EXPOSITION PARK BRANCH LINE RAIL TRANSIT CORRIDOR ROUTE

Final Environmental Impact Report

LOS ANGELES COUNTY
TRANSPORTATION COMMISSION

October 1992

FIGURE 3.3-2
NORTHERN SEGMENT
ALTERNATIVE 1b
Separate-Bridge

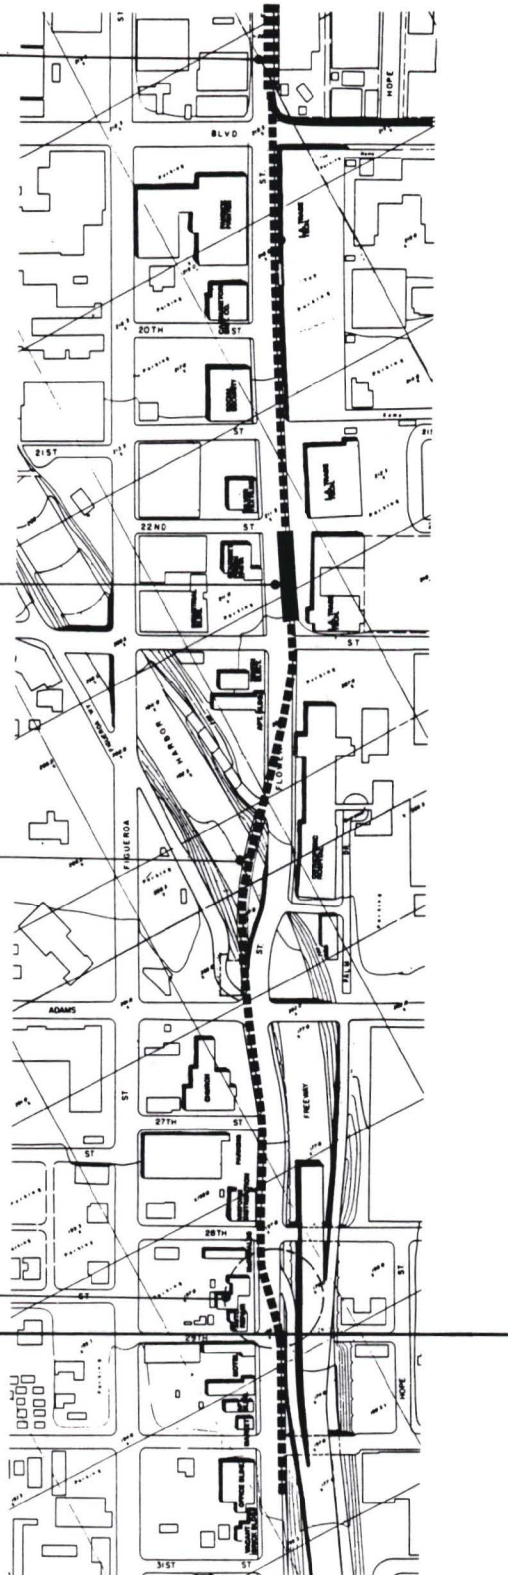
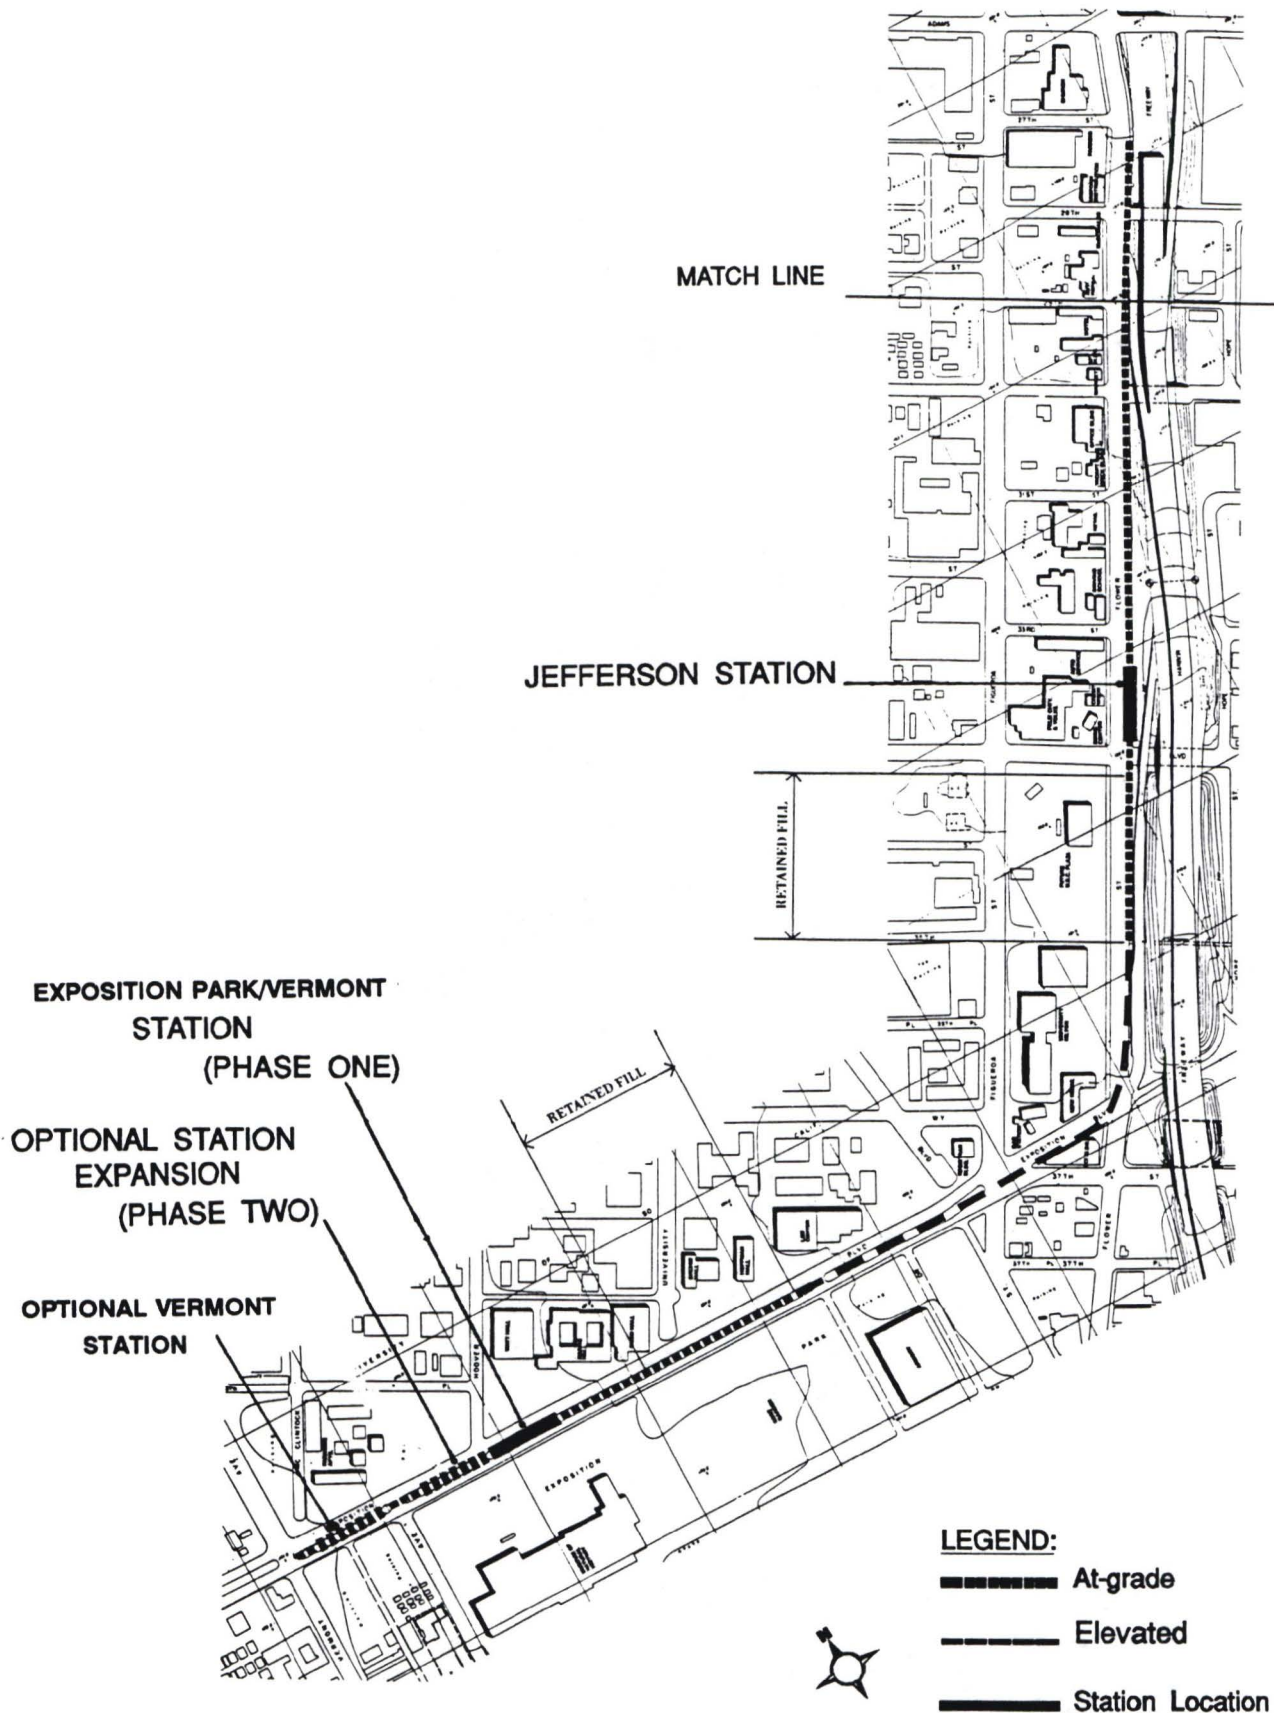
The hazard to autos is the same as for pedestrians. While there is confusion in the EIR as to where tracks in alternate 1b would cross Flower Street, Figure 3.3-2, wherever that crossing is in the Hospital's block, there would be continuous auto/train friction.

171. **Figure 3.3-2** is a summary map showing all of the alternatives under consideration. Each alternative is again presented in larger scale in Section 3.3, **Figures 3.3-1 to 3.3-5**.

FIGURE 5.3-3

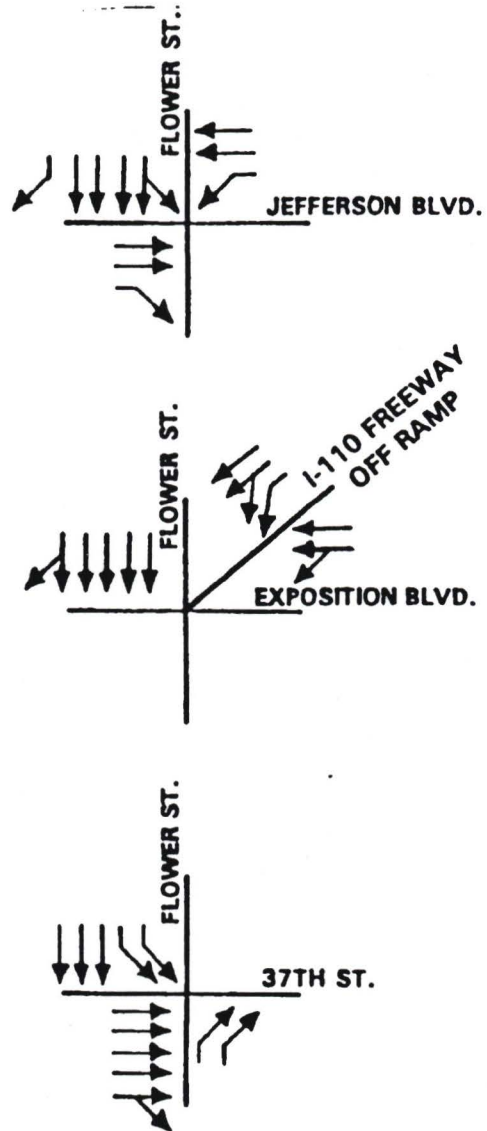
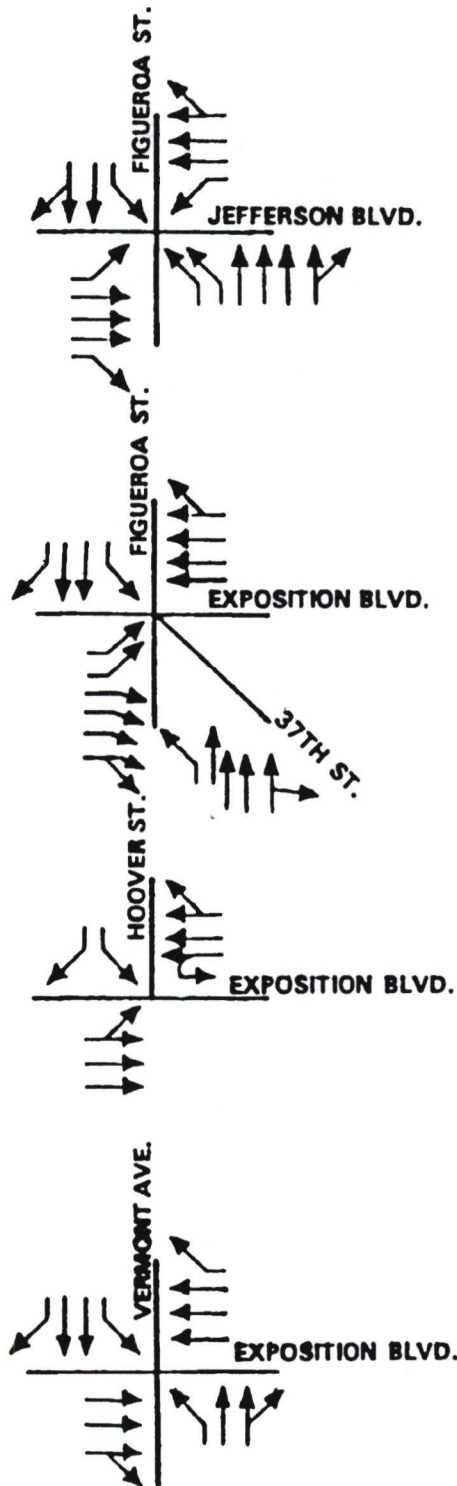
- o p 5-28: Figueroa Street - See earlier comments regarding two-way street operation. (69)
- o p 5-30: Fig. 5.3-3: Figueroa Street and Washington Boulevard for westbound show one right turn lane, three through lanes, and one left turn lane. (70)

- o p 5-30: Fig. 5.3-3: 23rd Street and Figueroa Street. For eastbound show on right turn lane, not two right turn lanes. (71)
- o p 5-30: Fig. 5.3-3: Adams Boulevard and Figueroa Street. For southbound show one right-turn lane, two through lanes, and one left-turn lane. For northbound show one left-turn lane, three through lanes and an optional through-right turn lane. (72)

- o p 5-30: Fig. 5.3-3: Flower Street and Washington Boulevard. For southbound show the left-turn lane as an optional left-turn through lane. For westbound show the optional left-turn through lane as a through lane; left-turns are prohibited. (73)

- o p 5-30: Fig. 5.3.3: 23rd Street and Flower Street for eastbound show the optional through-right lane as a right-turn lane. For northbound show a left-turn lane, in addition to a right turn lane. (74)

- o p 5-30: Fig. 5.3-3: Adams Boulevard and Flower Street. For southbound show two through lanes, not three. (75)
- o p 5-31: Fig. 5.3-4:
 - * Figueroa Street and Jefferson Boulevard: for northbound show a single left turn, not a double left turn. (76)

- 69. See Response #57.
- 70. The lane configurations reflected on **Figures 5.3-3** and **5-3.4** were based on the "Advanced Plan; Harbor Freeway (I-110) Transitway Figueroa Street - Flower Street 38th Street to 21st Street" provided to LACTC by LADOT at the outset of this EIR process, as well as existing geometrics along Washington Boulevard. The See Response #49.

FIGURE 5.5-2
PROXIMITY OF ORTHOPAEDIC HOSPITAL AND
APARTMENT BUILDING TO THE PROPOSED RAIL LINE

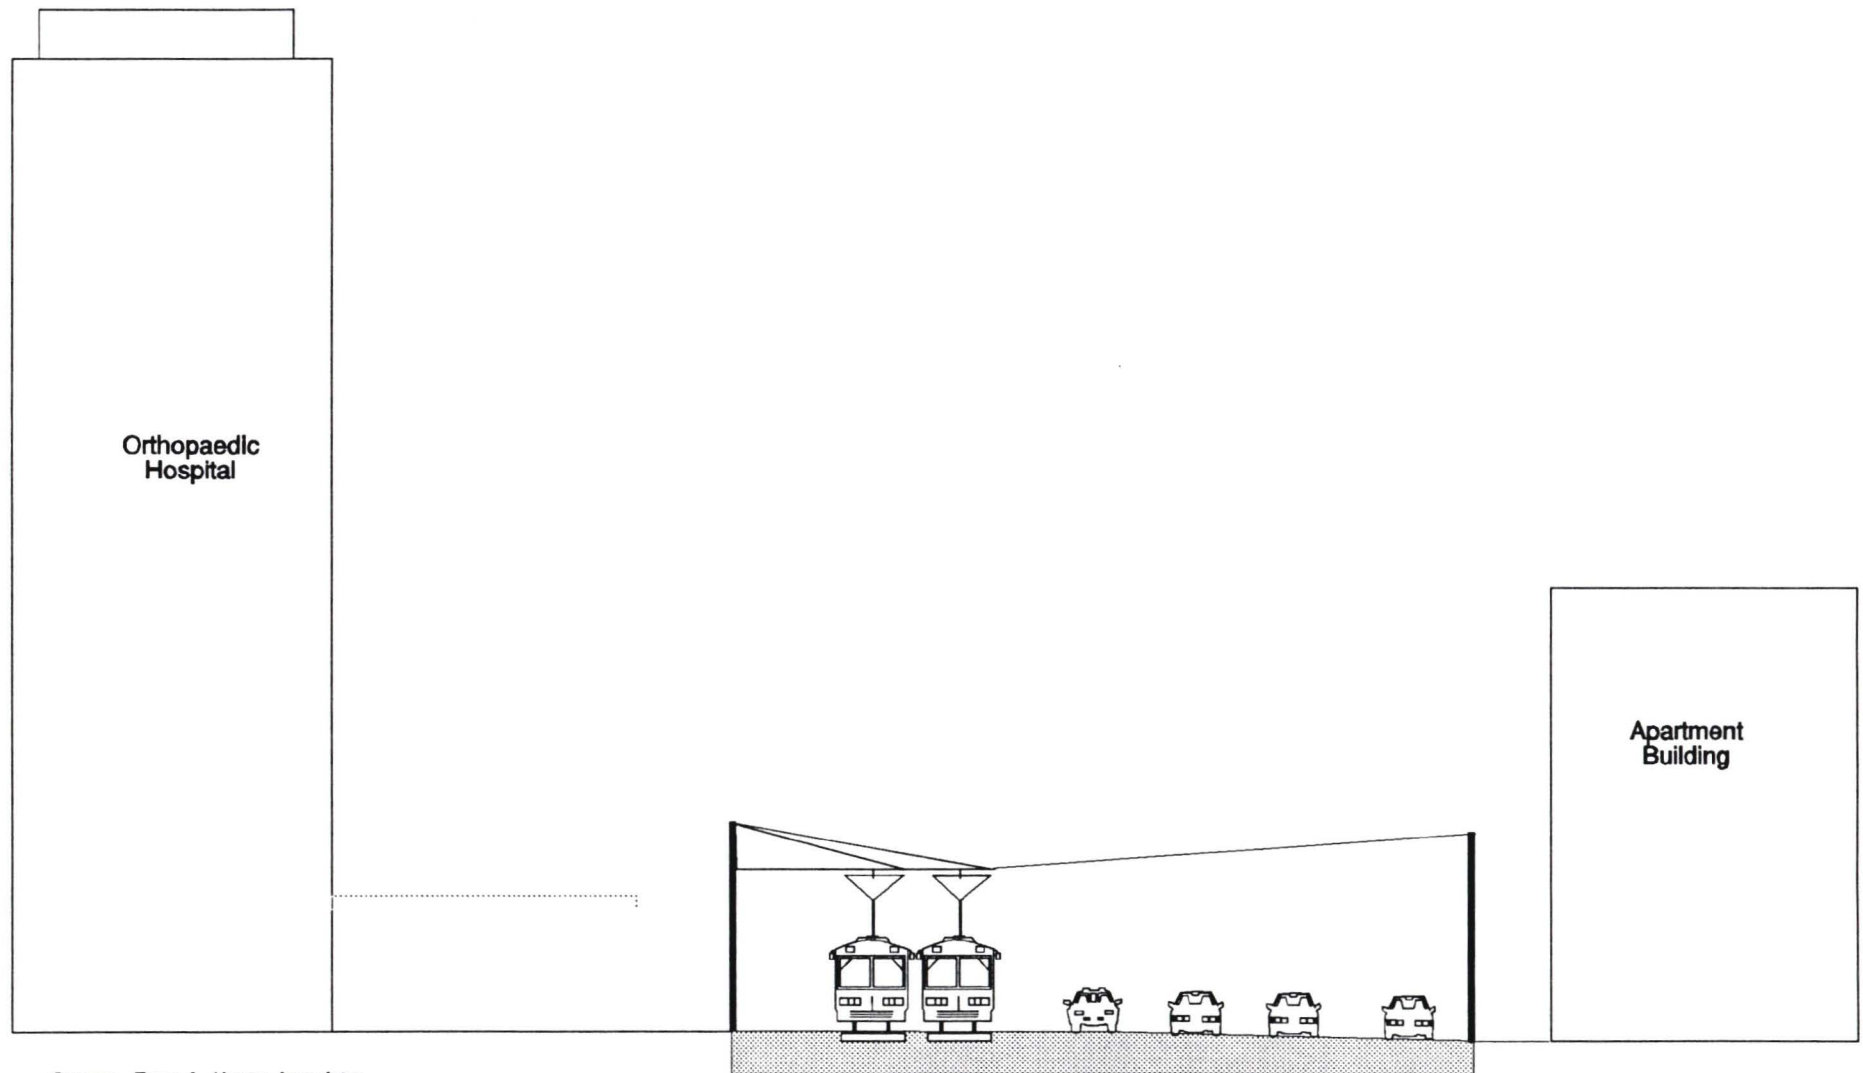
Typical cross-section (Figure 5.5-2) opposite Page 5-78 should be marked with the Flower Street widths and lane widths. Full analysis of the cross-section cannot be made unless existing widths and proposed widths are shown.

13. See Response #10.
14. **Figure 5.5-2** is intended to convey the general relationship of the rail line to the adjacent buildings for purposes of public presentation. This figure is a summary of detailed engineering cross sections that accompany the plan and profile for the alignment. The plan and profile sheets are scaled drawings that also show right-of-way widths. The plan and profile sheets are available for review at LACTC.

FIGURE 9.0-1
ALTERNATIVE 1b
With Mitigation

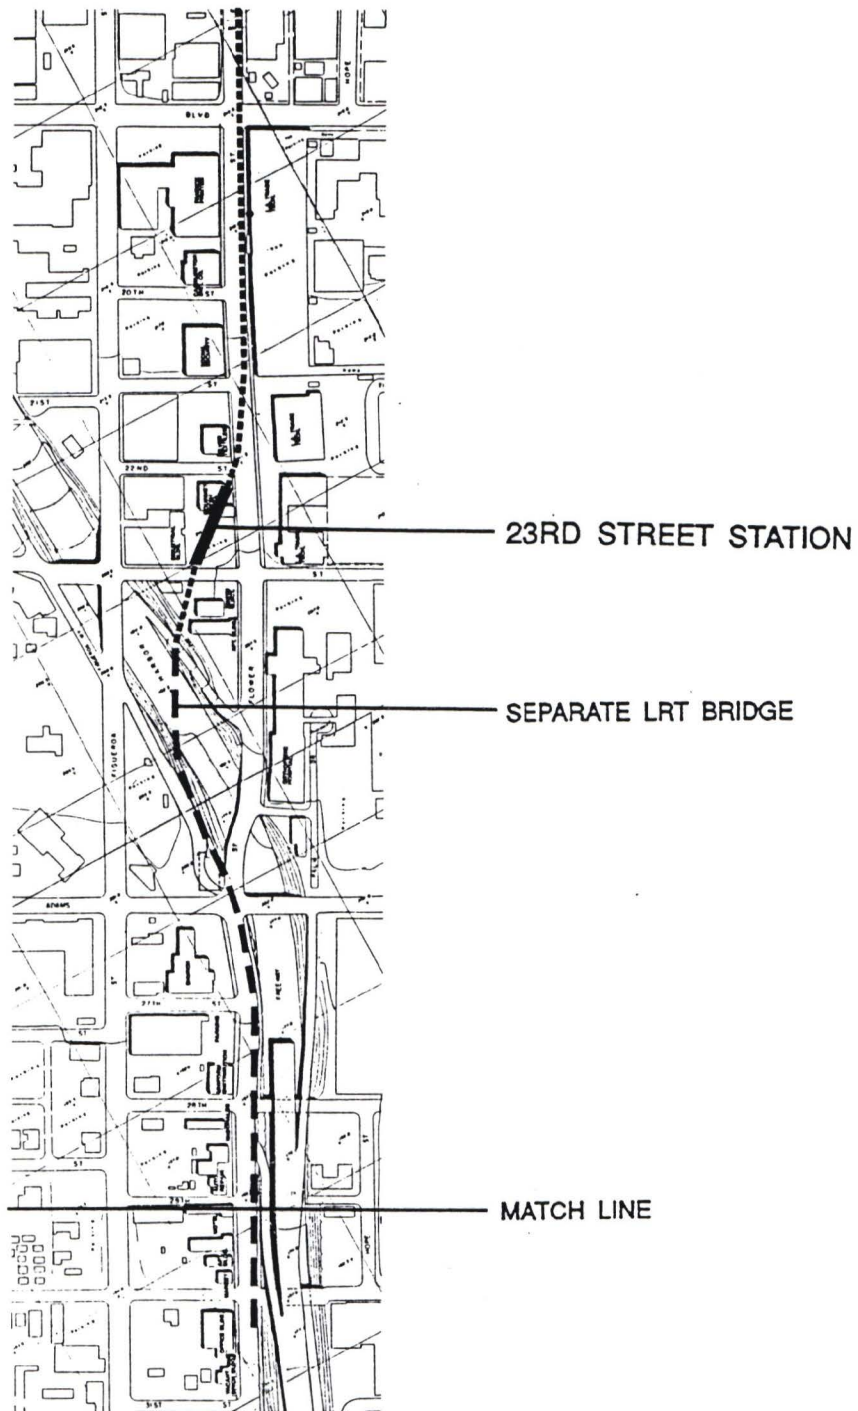
During the public review period a number of issues were raised regarding the impacts of Alternative 1b, Washington Boulevard to 29th Street (Separate Bridge). As a result of issues raised during the public review process the Los Angeles County Transportation Commission has developed a modified Alternative 1b which would mitigate the impacts and concerns raised. This mitigated Alternative 1b is presented in Chapter 9.0 of this report and hereby replaces Alternative 1b presented in the Draft portion of this EIR. The Draft EIR portion of this report remains unchanged except for those items identified on the following Errata Sheet and the Summary Section. The Summary Section has been revised to incorporate this mitigated Alternative 1b as well as any new mitigation measures which have been developed in response to comments raised.

This mitigated alternative replaces Alternative 1b presented in the Draft EIR in response to issues raised during the public review and comment period. This mitigated alternative would be at-grade and would extend along the east side of Flower Street from the Washington Street Station to about 22nd Street. At 22nd Street it would cross Flower Street where the proposed 23rd Street Station would be located on the west side of Flower Street between 22nd and 23rd Streets. At 23rd Street, the line would curve further west behind the four-story apartment building located on Flower Street. Just south of the Harbor Freeway crossing, the line would curve to the east and would run along the east side of Flower Street from Adams Boulevard to the Jefferson Street Station. The LRT line would become elevated just south of the apartment building and would continue on an elevated structure across the depressed Harbor Freeway surface to about 33rd Street where it would again be at-grade at the proposed Jefferson Street Station. This alignment is shown on **Figure 9.0-1**.
